**CITY OF MERCED PROJECT NO. CP220061
CHANGE ORDER NO. 2**

PROJECT NAME: Community Park 42

Additional work to add underground electrical, water. Quantity adjustment for additional asphalt per the contract unit price.

REQUEST FOR INFORMATION

DATE: 7/2/23

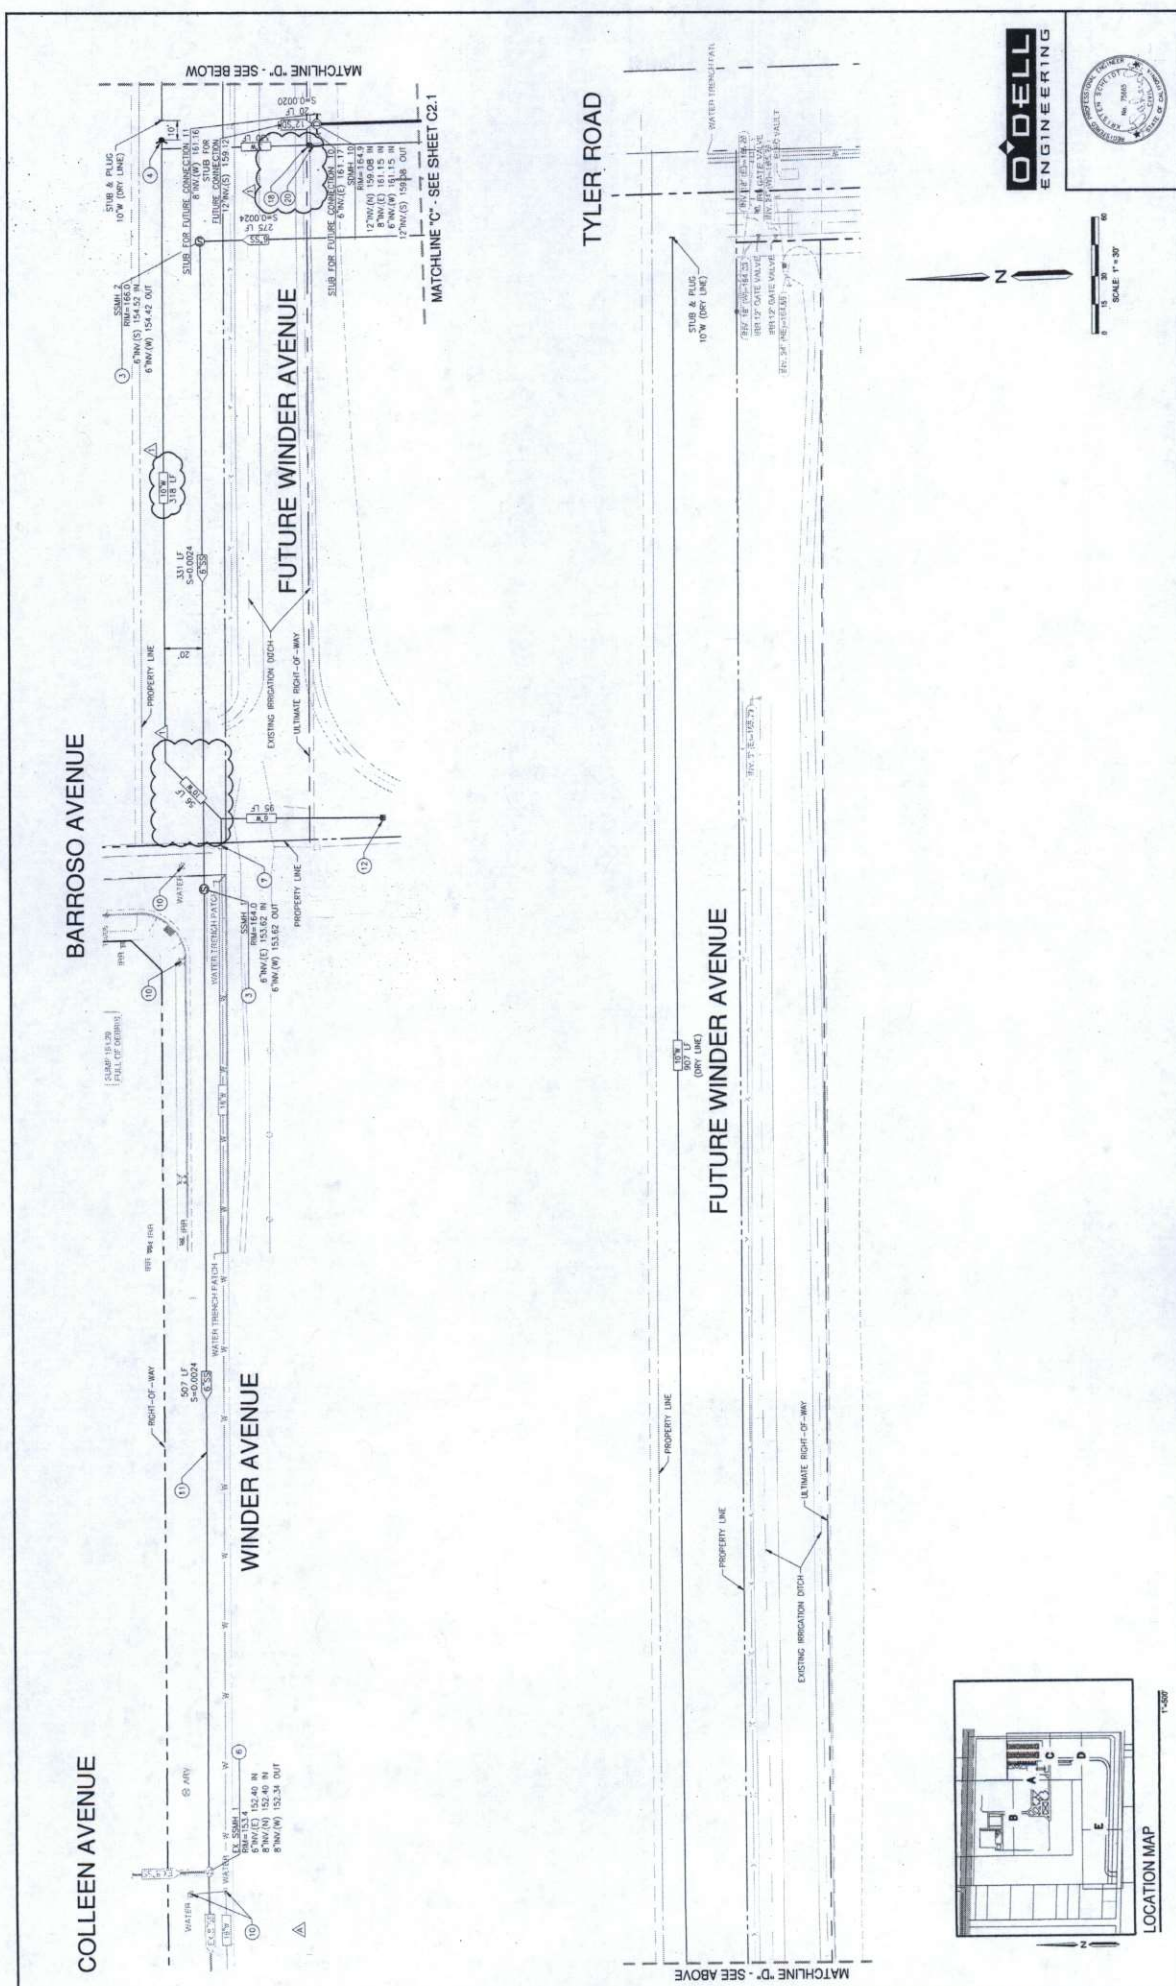
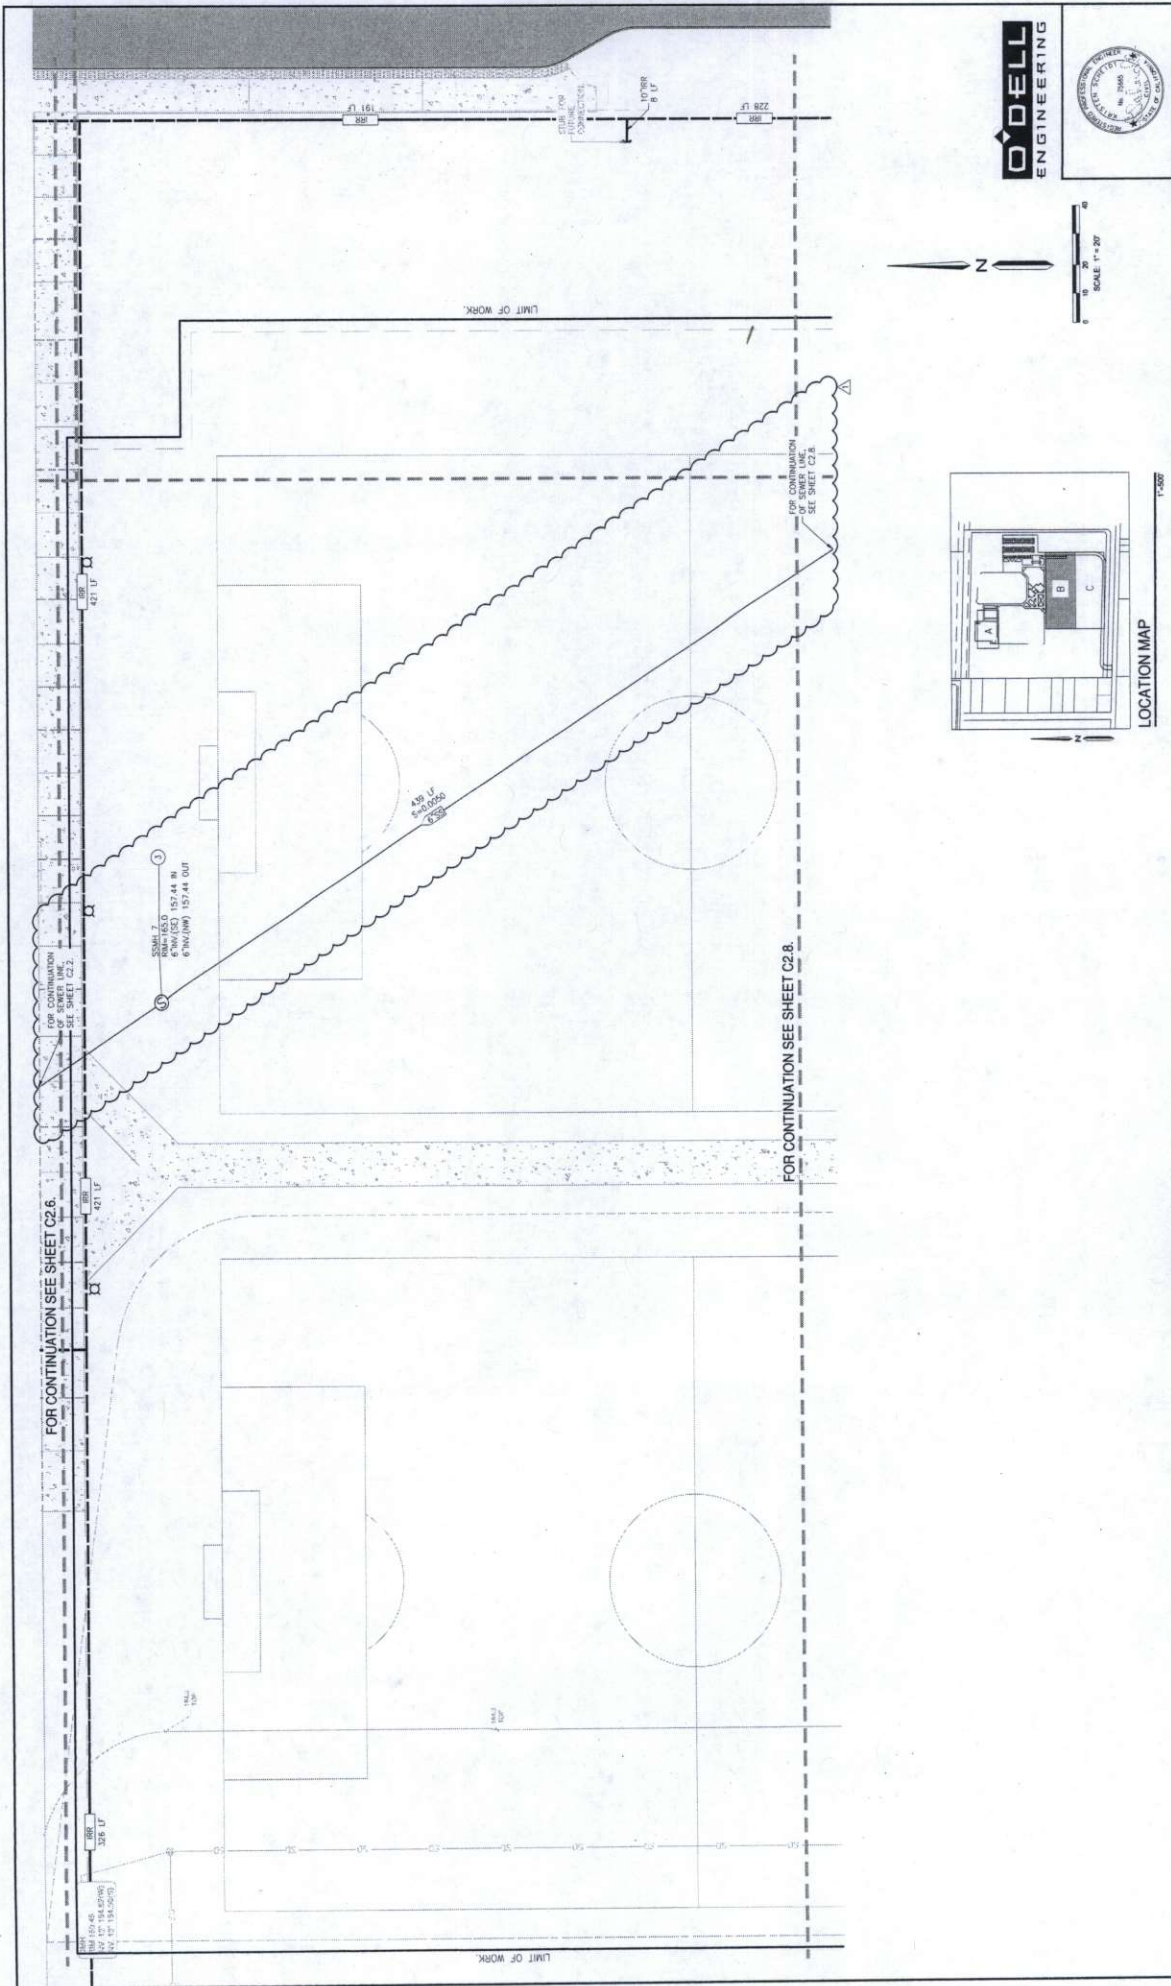
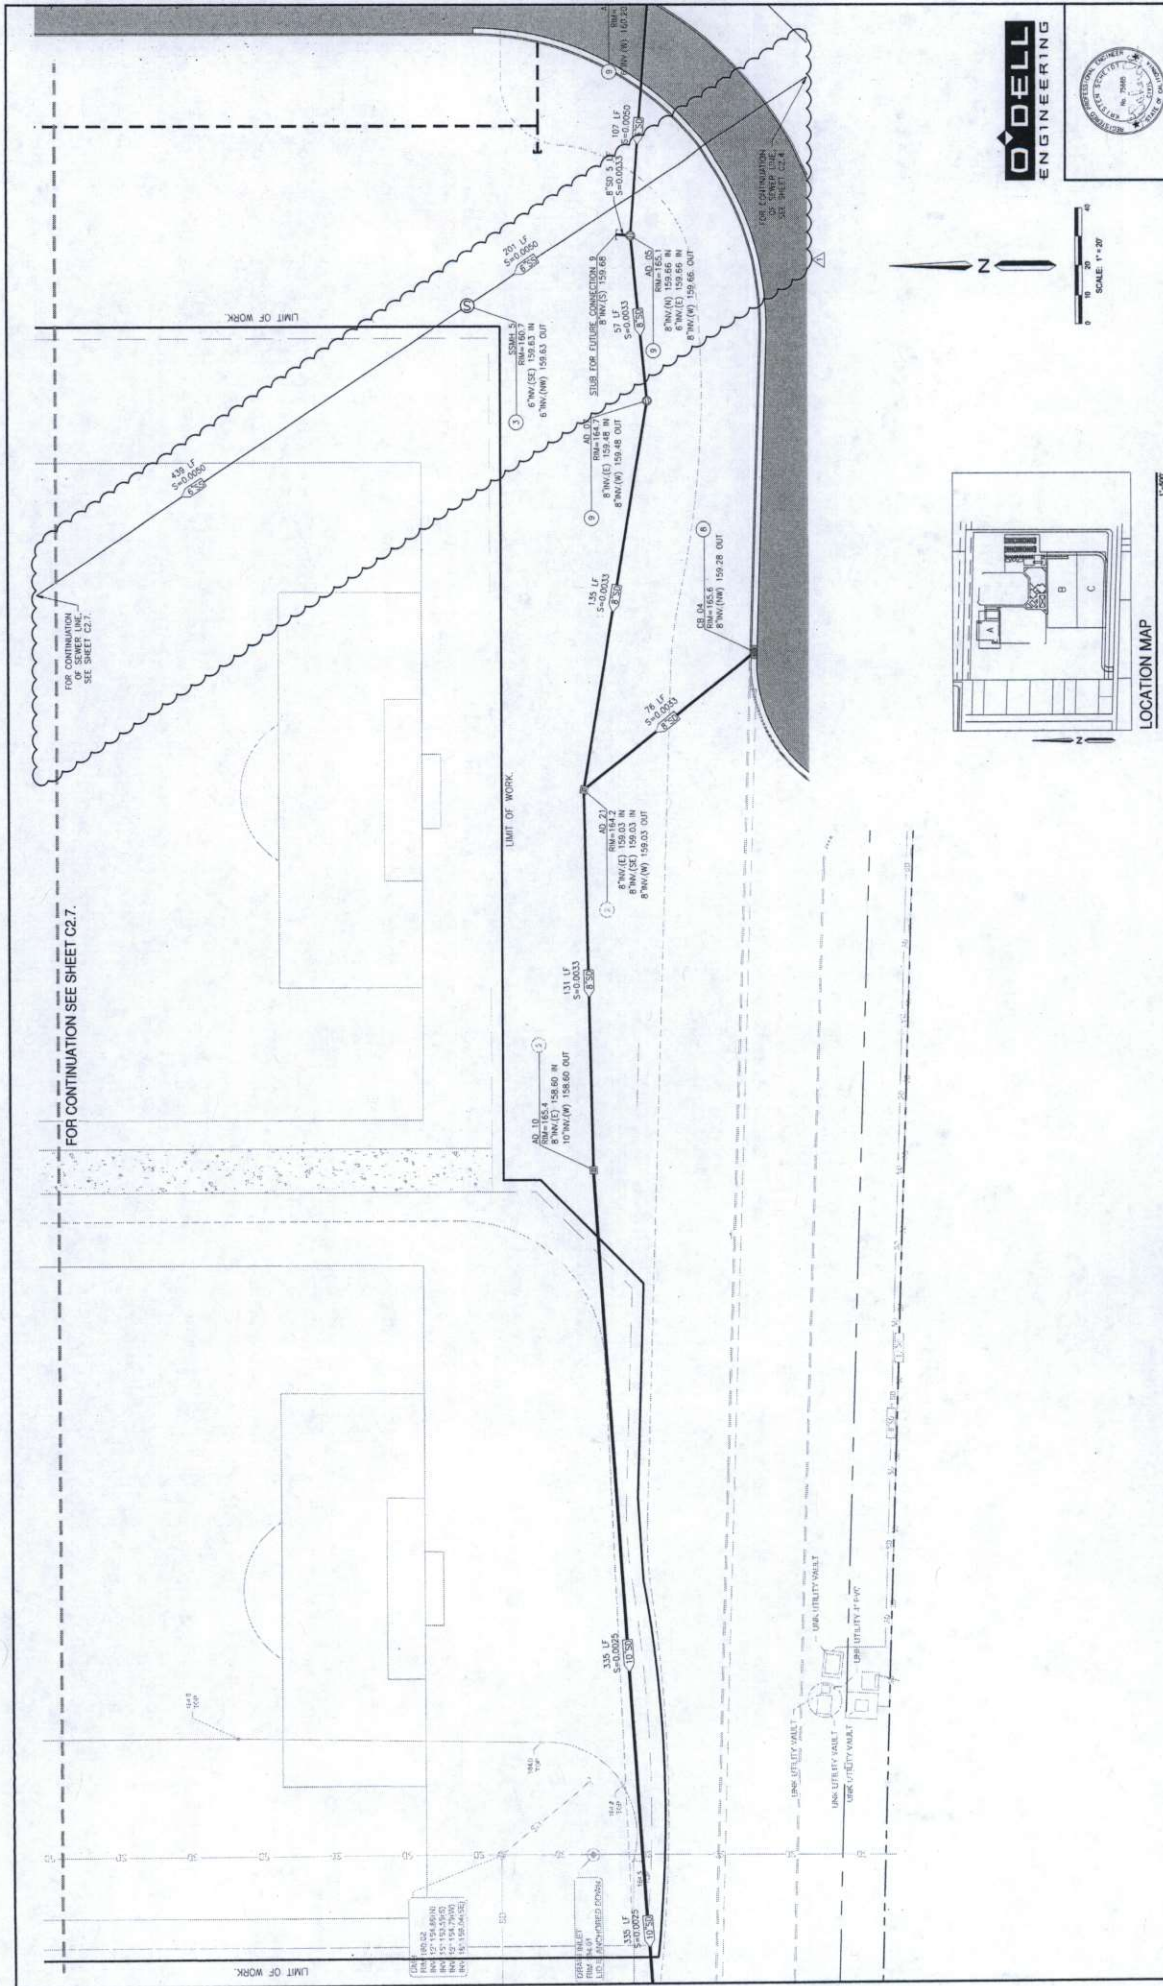
REQUEST: Bid Item # 23 - 6" Sewer shows a quantity of 1,170 LF. When we preformed our take off, we found 2,830LF shown on the plans. That's an additional 1,660LF. Please verify quantities.

REPLY: See sheets C2.1 to C2.5 and C2.7 to C2.8 Rev 1 dated 8/16/23 showing revised sewer line routing between concession building and well site 20. Line item 23 on Bid Schedule A to be updated to 2,561 LF.

EXP. BY: 11 / 15	FILE NO. 40320-UP DND
DATE: 01/12/2023	SHEET
CAL. BY: SK/DK/JN	C2.5
DATE: 01/12/2023	26 of 75
SCALE: AS SHOWN

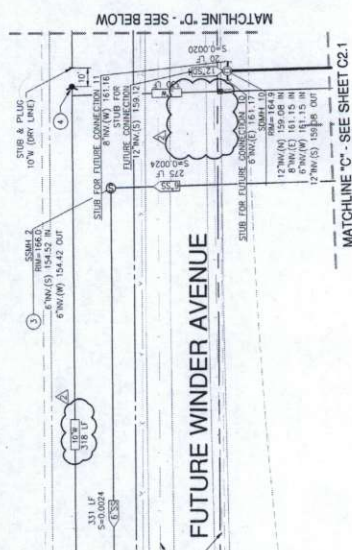
REQUEST: Bid Item # 33 - 10" Water Line (Offsite) shows a quantity of 1,780 LF. When we preformed our take off, we found 1,290 LF shown on the plans. That's 490 LF less than shown for the bid item. Please verify quantities.

REPLY: Upon review of the bid documents, there is 1,281 LF of 10" water line along Winder. See attached sheet C2.5 revision 2 for revised pipe sizes. Line item 22 on Bid Schedule A to be revised to 1,281 LF.
